APPENDIX 11

11A ANSWERS TO QUESTIONS

SACRAMENTO MUNICIPAL UTILITY DISTRICT

FIGURE 11A.1-1
AREA MONITORING SYSTEM

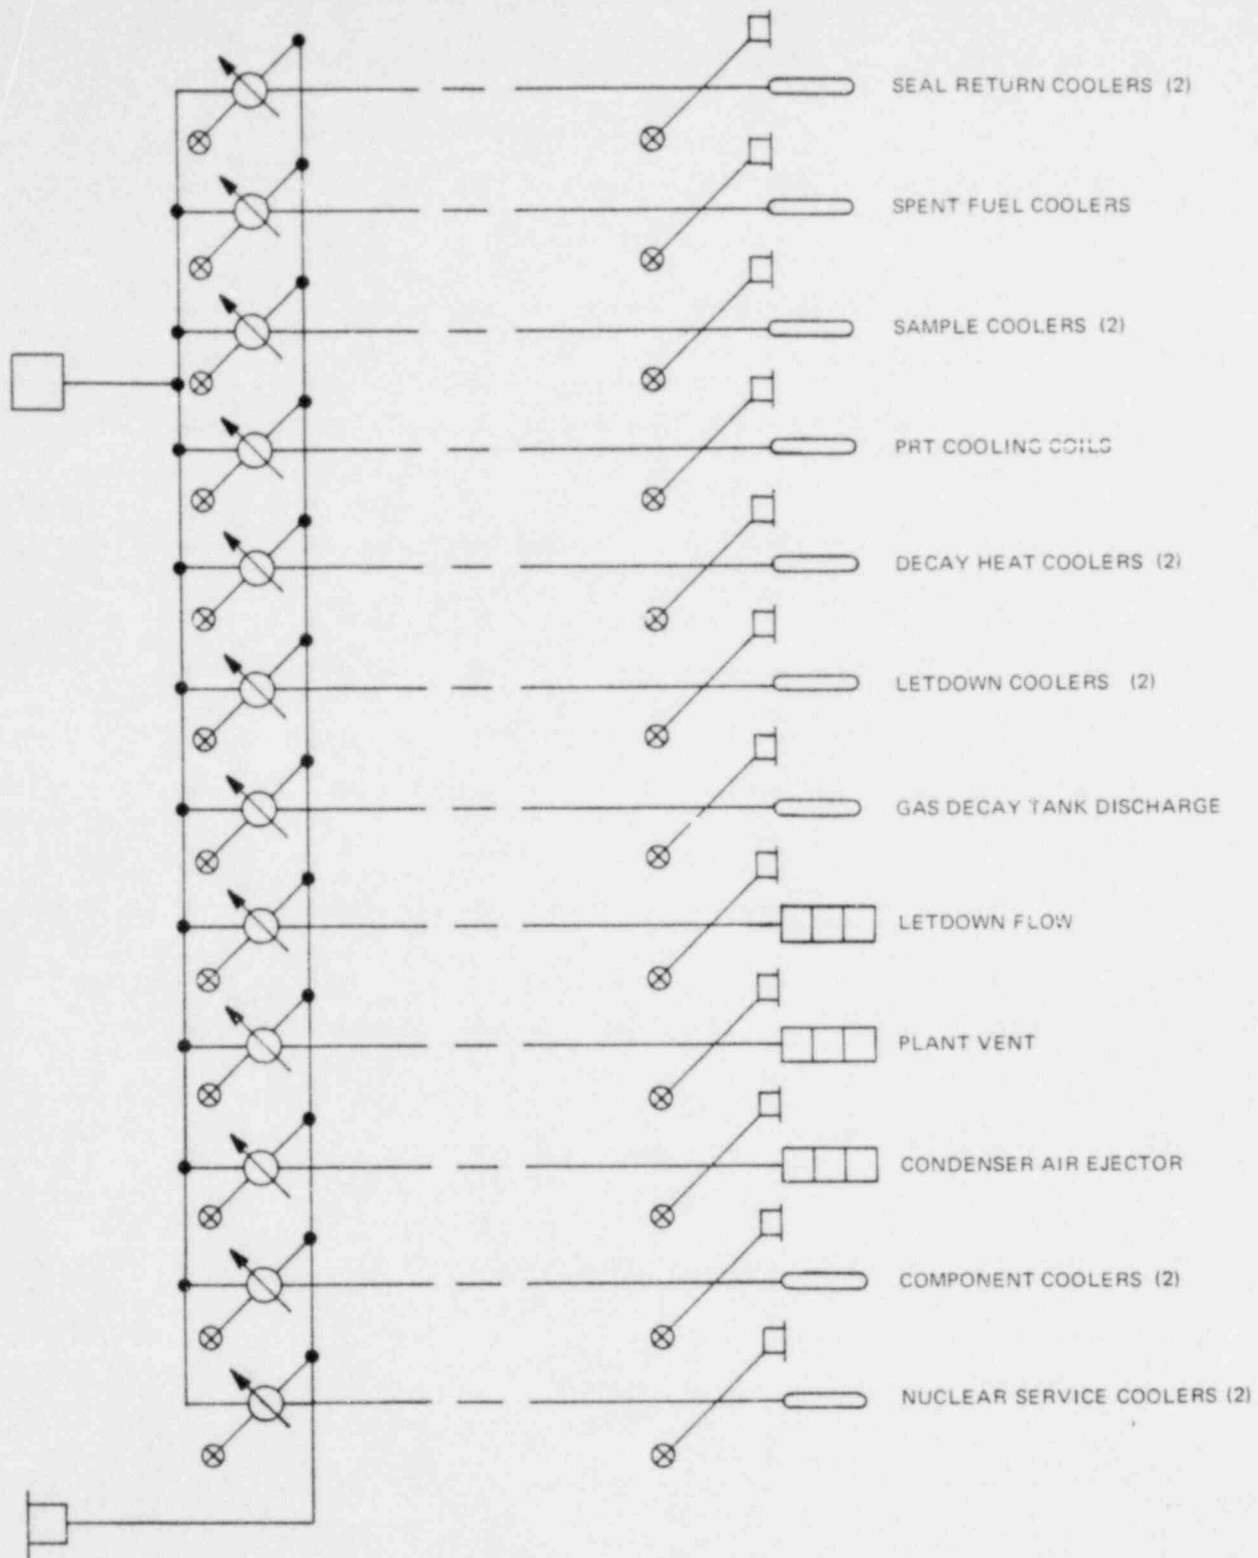
QUESTION
11A.1 Provide a Radiation Monitoring System schematic similar to the format of Figure 7.1-2 which indicates location, equipment type, power sources, and interlock functions. The schematic should show the relationship of the area, waste and gas disposal, ventilation, and site monitoring systems. The schematic should be accompanied by adequate description.

ANSWER
Refer to
11.2.2 The Radiation Monitoring System will consist of the Process Radiation Monitoring System and the area Radiation Monitoring System. Control room area monitors will be located close to the control console. The system functions are the early detection of an abnormal rise in radiation within the reactor complex and at selected locations on the reactor site perimeter, an audible alarm of the location of the abnormal radiation and the display of the level of the radiation as a visual or printed record. The Process Radiation Monitoring System function is to detect early indication of plant malfunction and the Area Radiation Monitoring System function is to warn personnel of excessive gamma radiation within selected working areas. Except for the waste gas disposal interlock, the signals from the monitoring system are not used for the automatic control of the equipment. Continuity of operation of the monitoring equipment is assured by taking power for the equipment from the Essential Power System. Schematics of the Area Monitoring and Process Systems are shown on Figures 11A.1-1 and 11A.1-2.
